# Bradley Heights Apartments

## A 236-Unit Apartment Development Puyallup, Washington

### Bradley Heights SS LLC

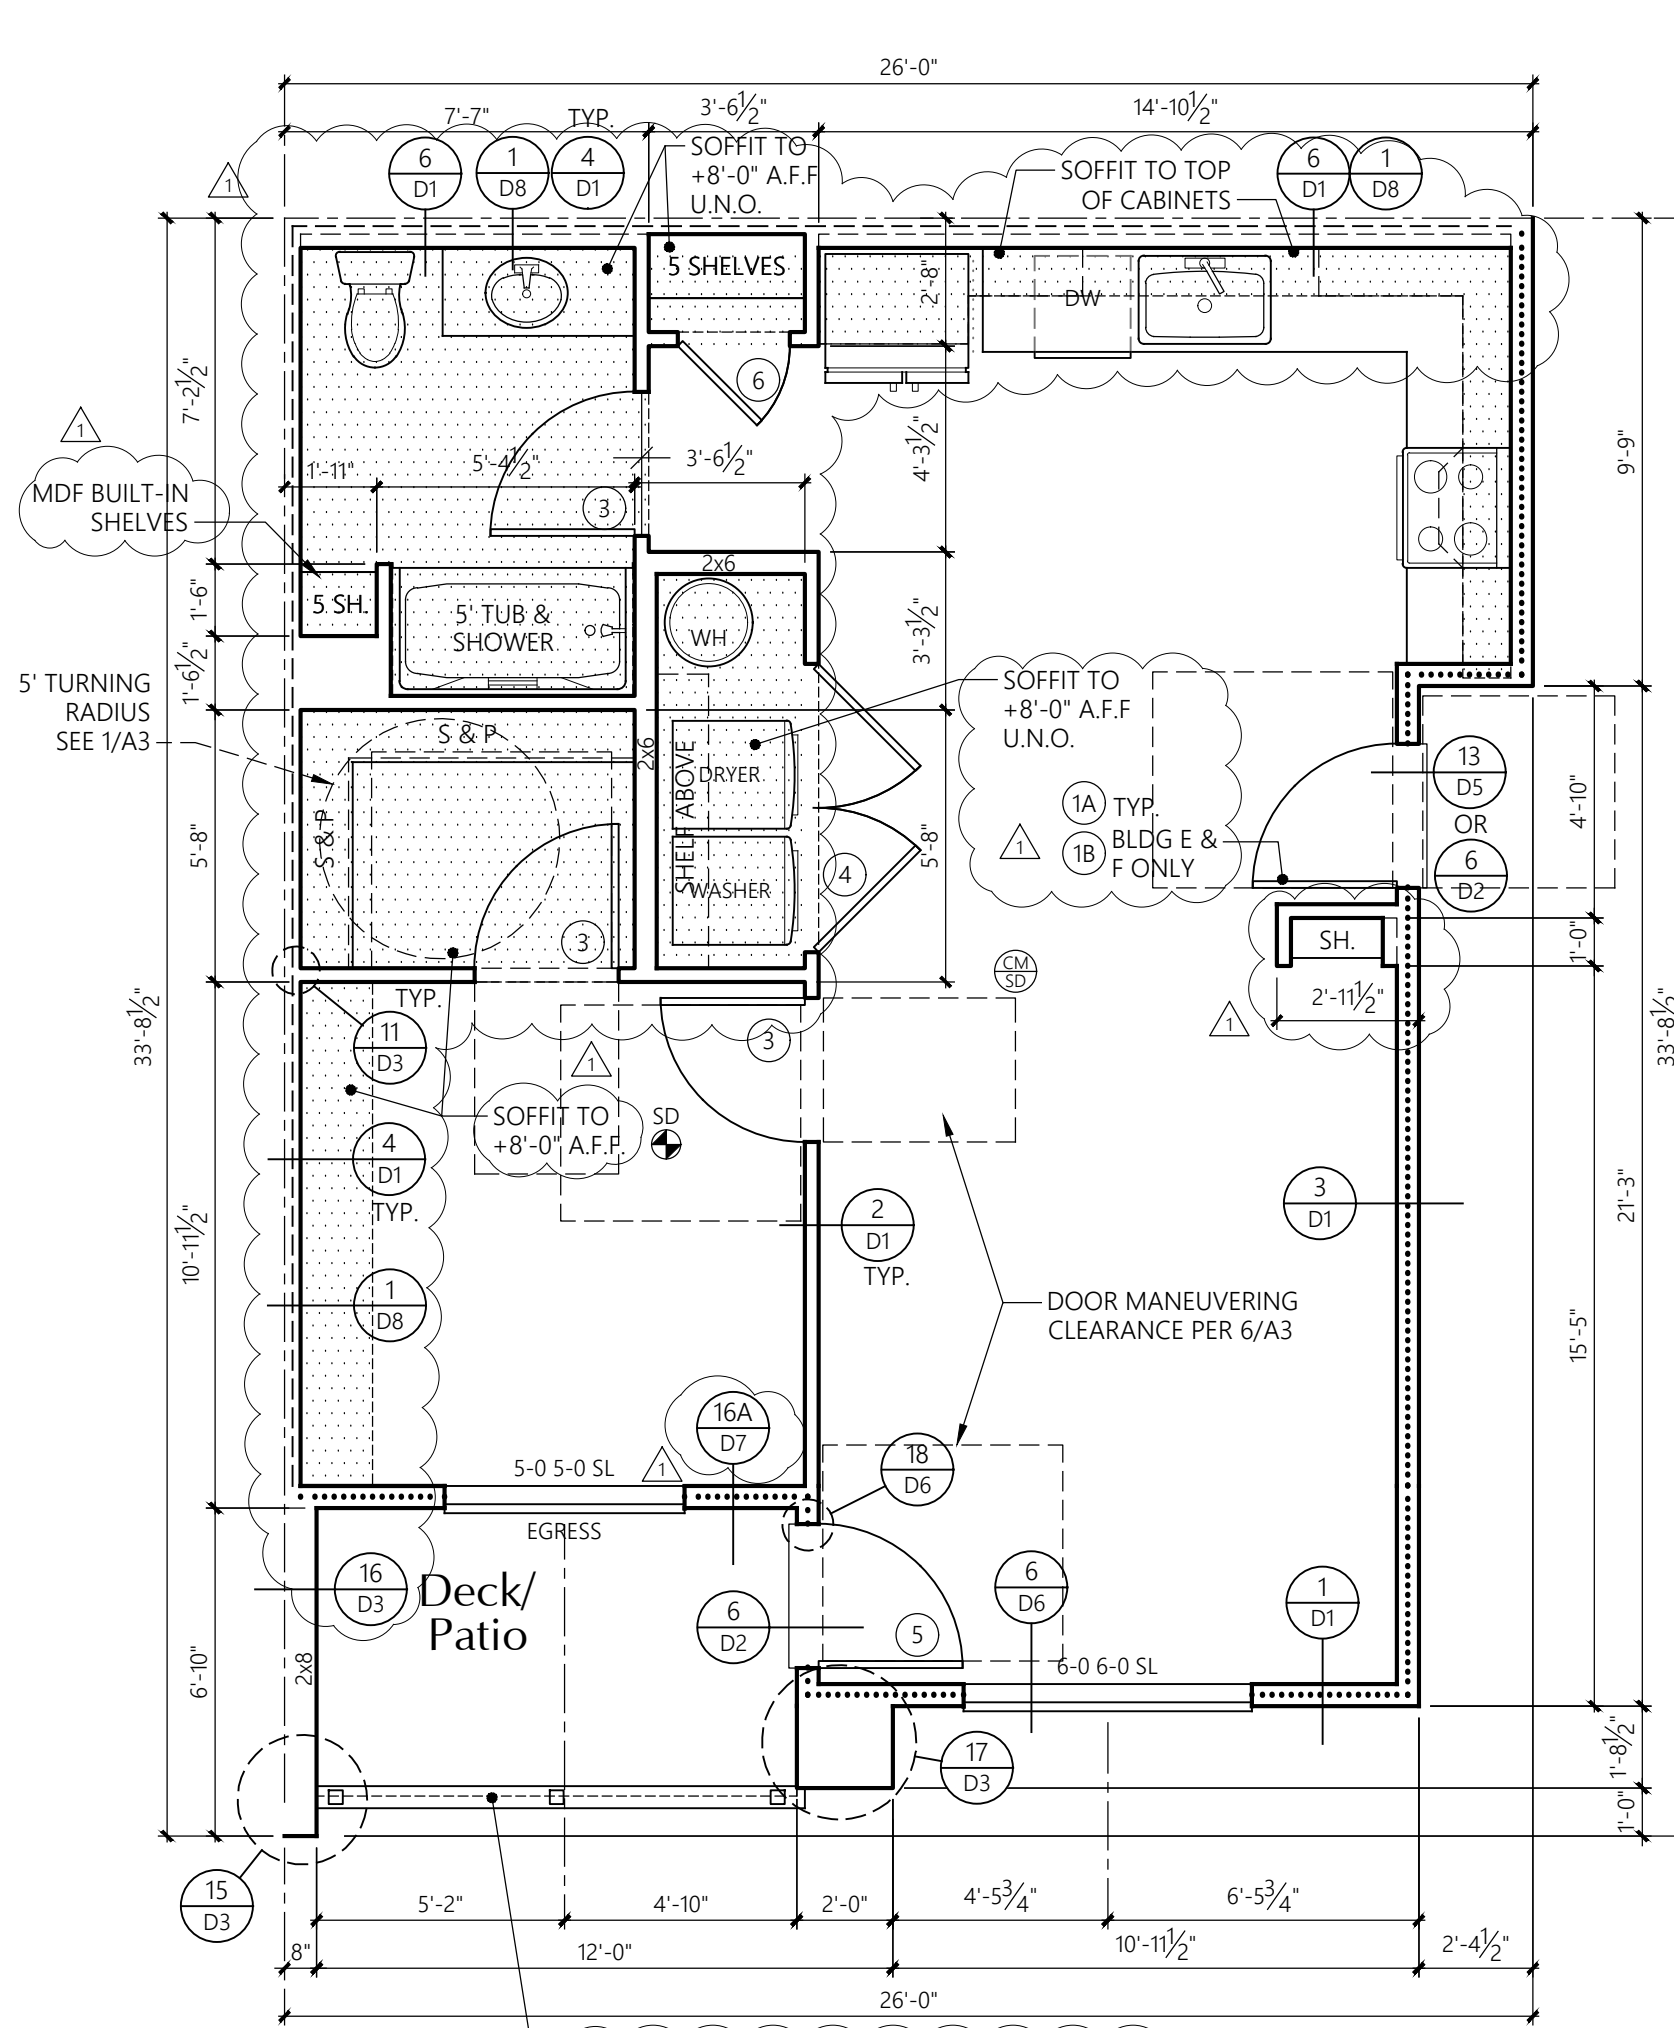
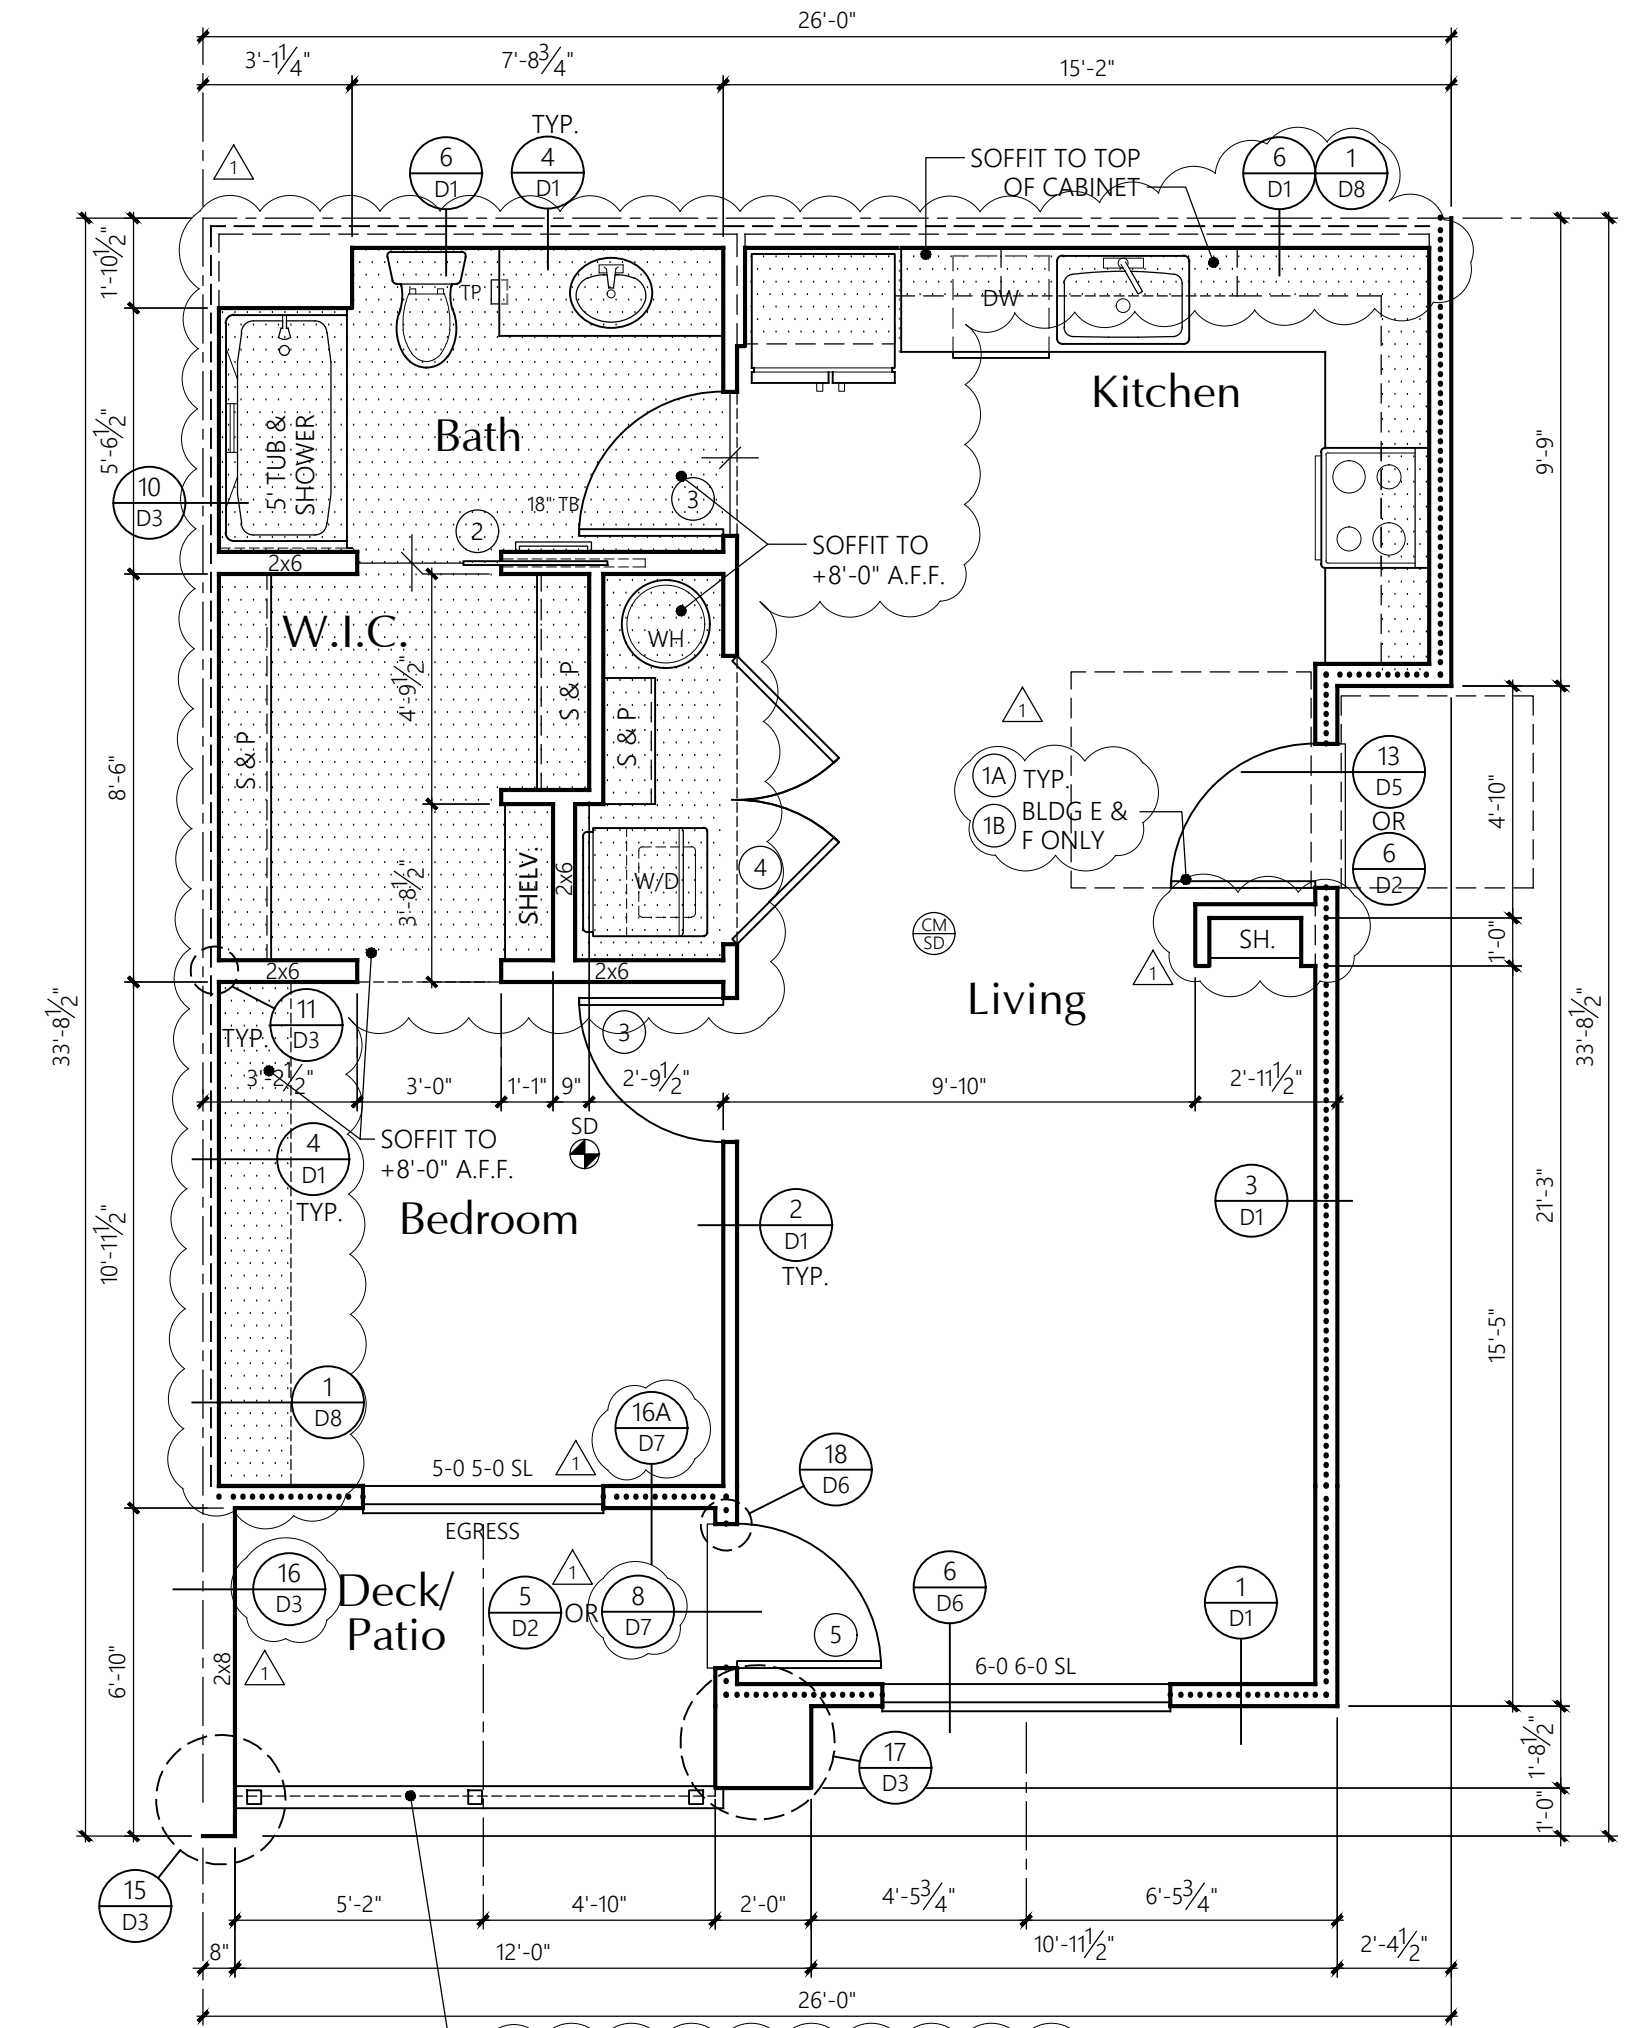
Door Key references Sheet U13 update plan or sheet numbers as needed, as there is no Sheet U13.

**Building H**  
Partial Architectural Foundation Plan

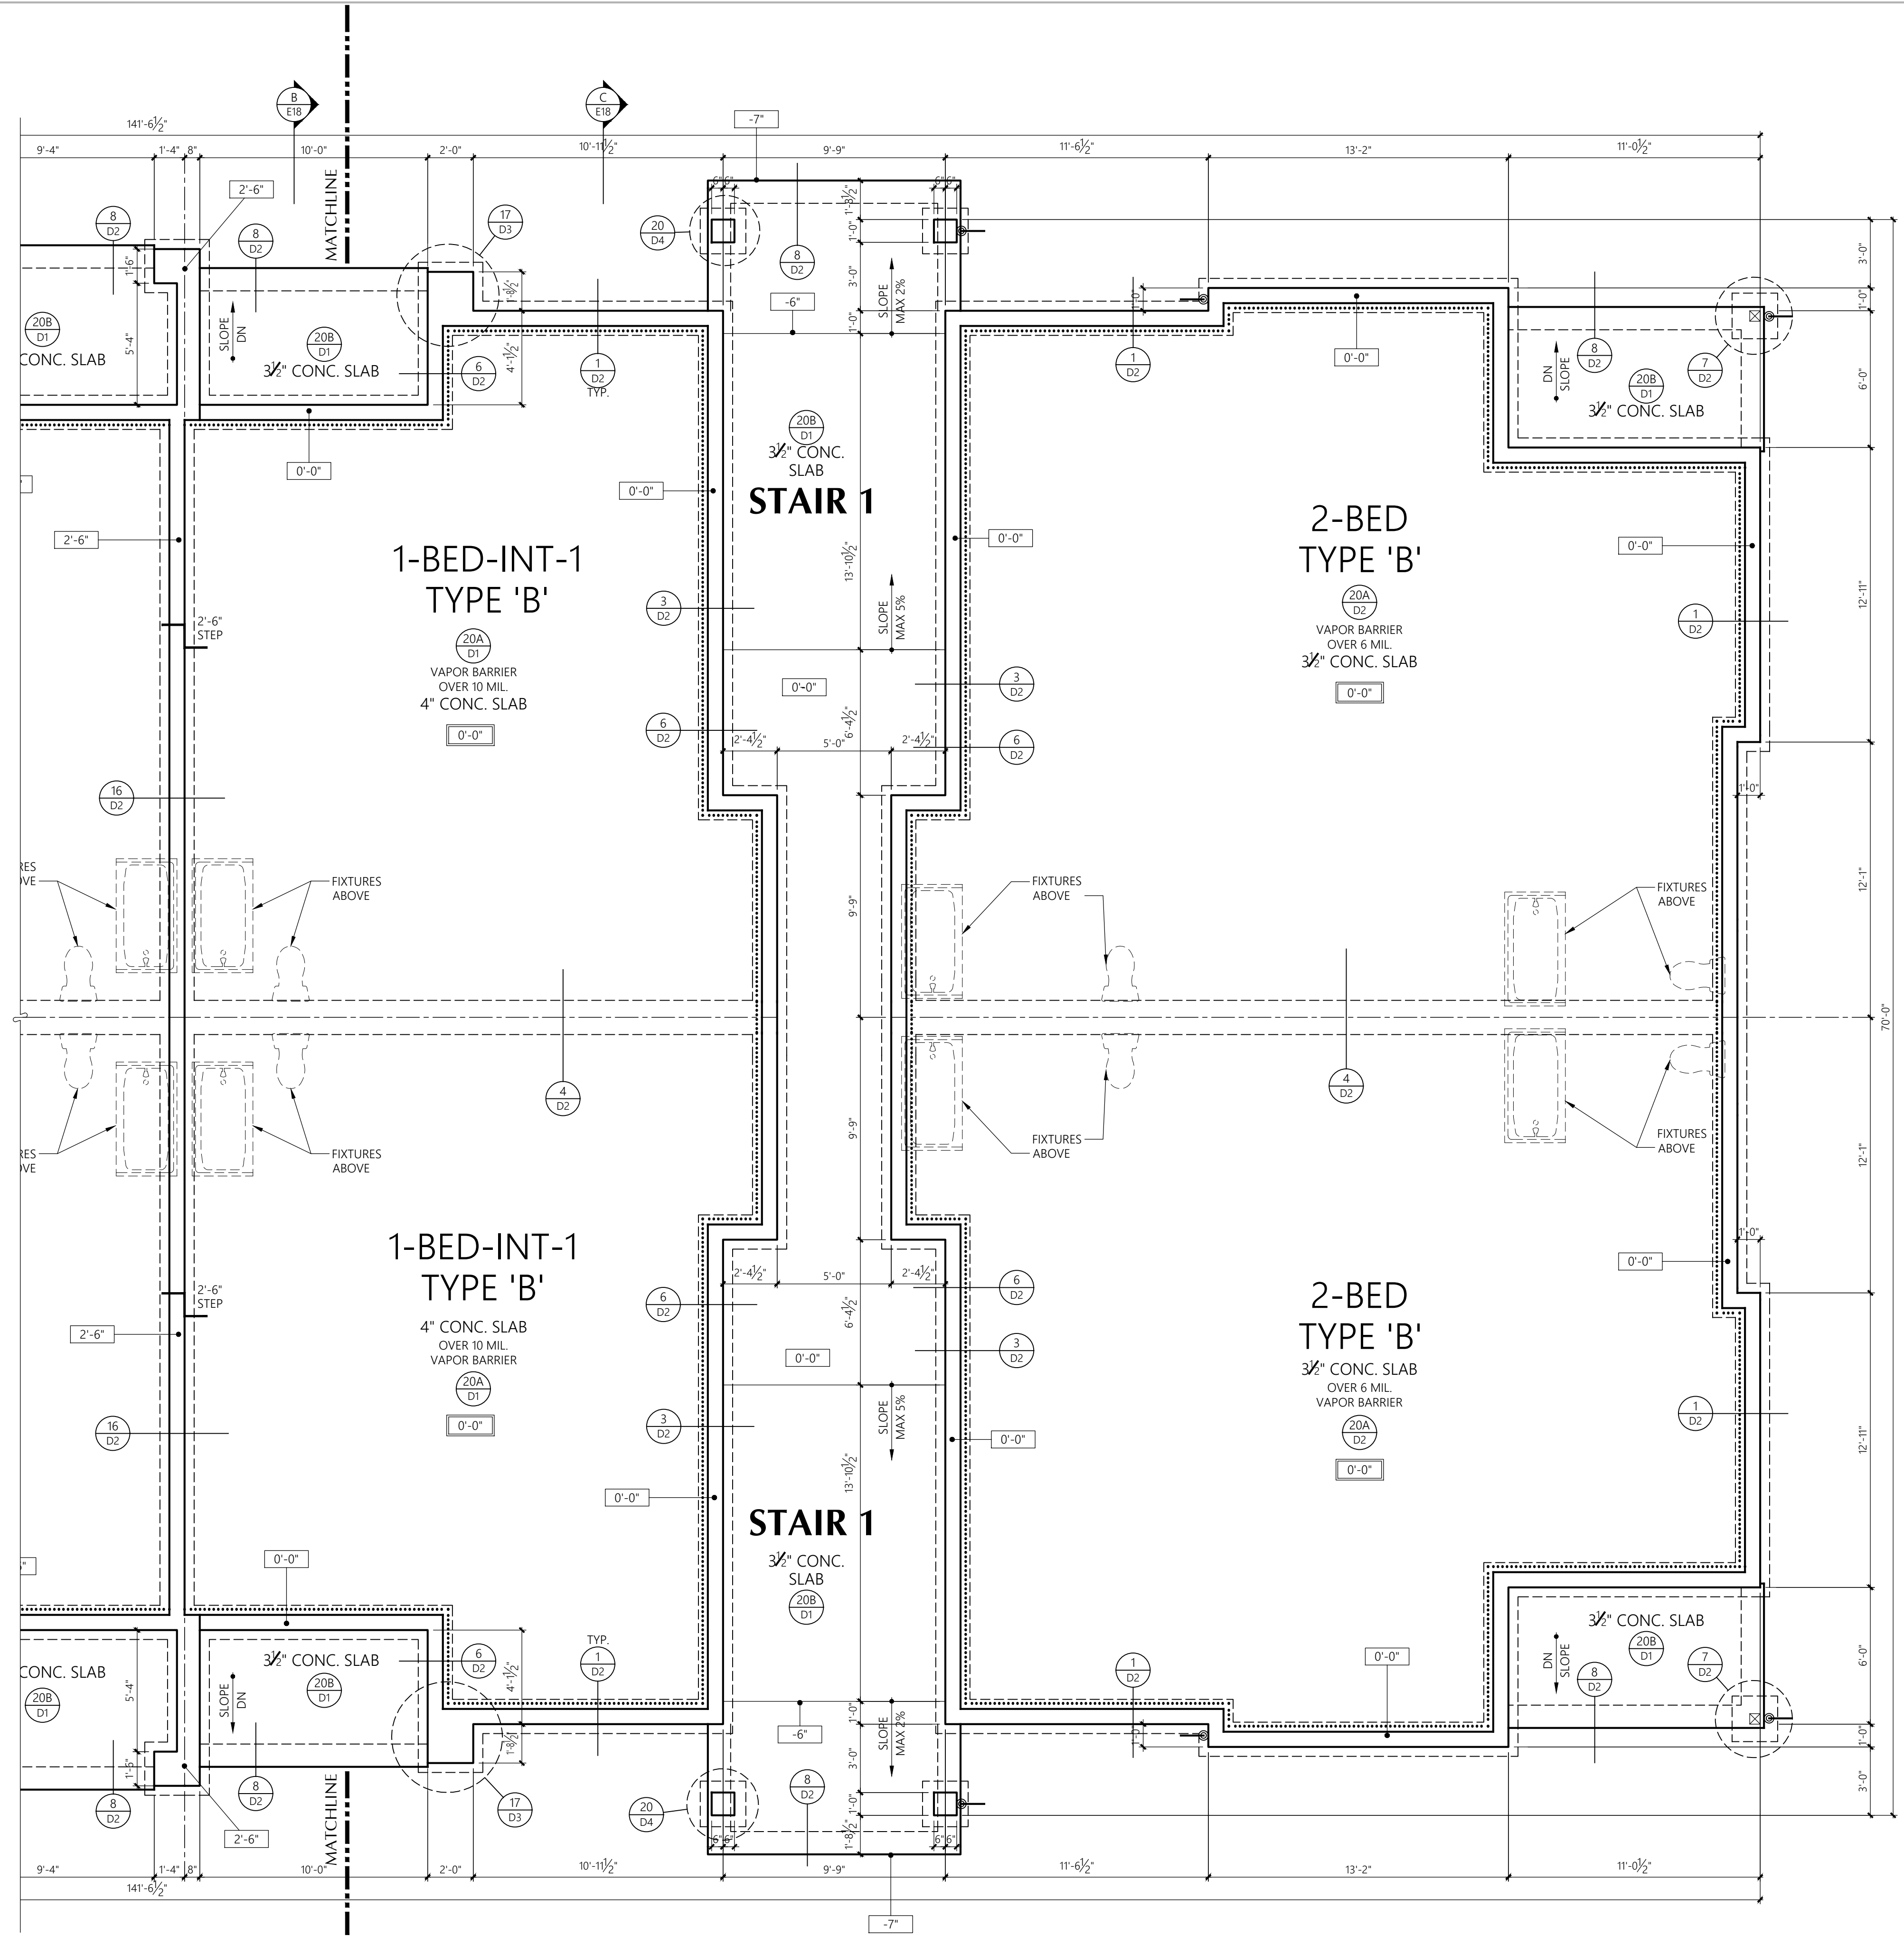
Update label as it does not match 1st level plan or site plan.  
(Construction Set, Sheet F14, Foundation Plan)
